Radar and Video Vehicle Detector (TCD402) V4.5.0

Release Note

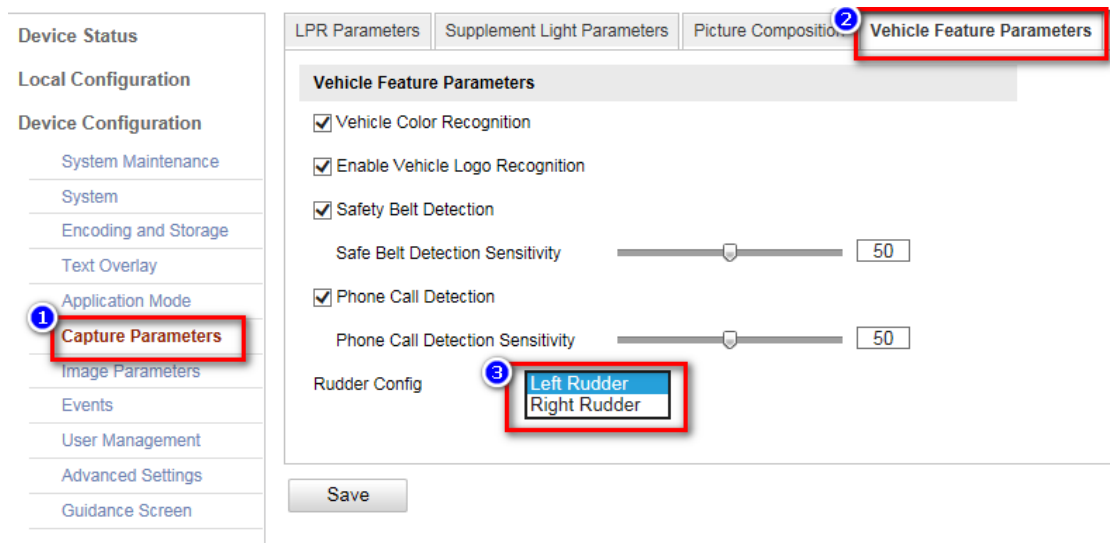
2.2.3. Modify the "Live View Picture" on the radar calibration page and GPS calibration page to "Live View"
